My customer is considering TO-92 package of DRV5032.

Figure 14. Direction of Sensitivity

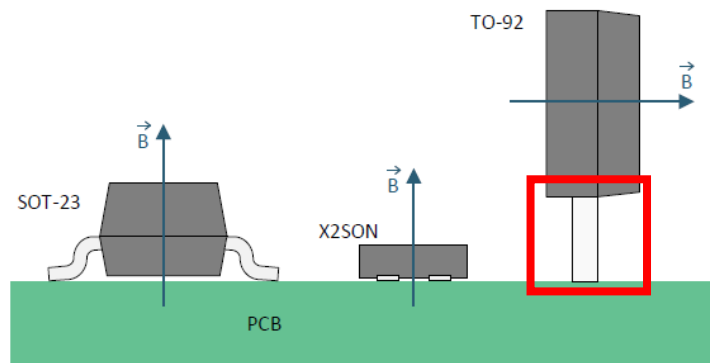
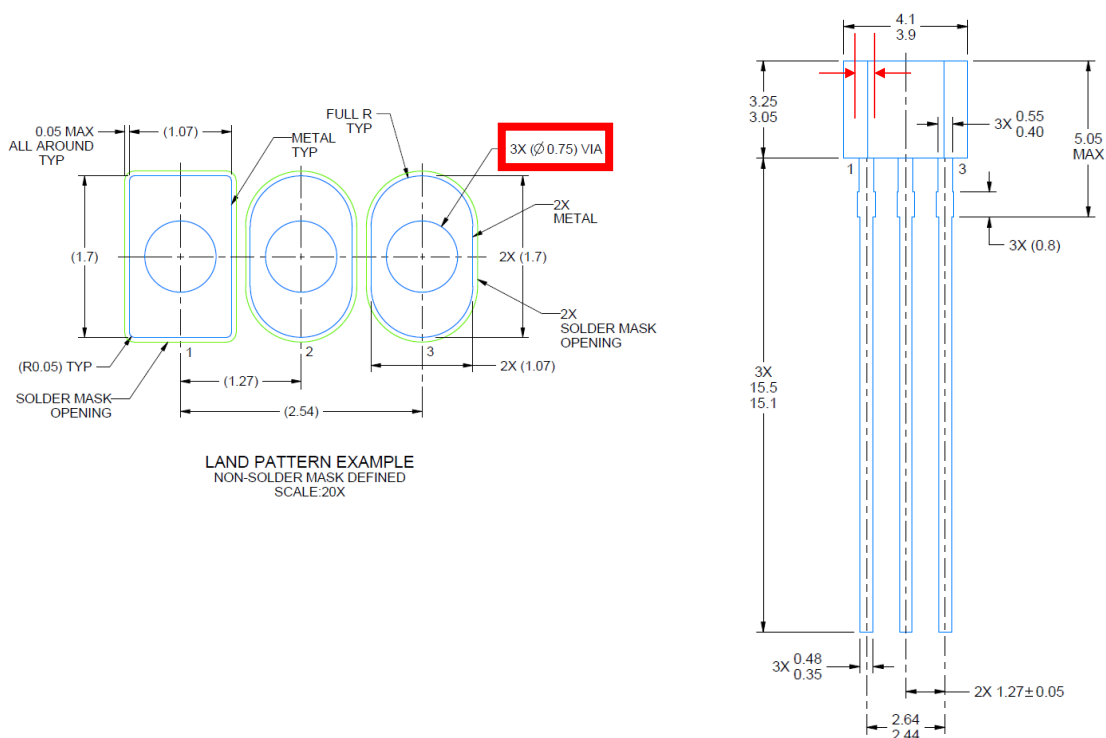
Q1 :

They want to fix the space surrounded by the red square in the figure below. What kind of method is there?

Is there only a way to use spacers?
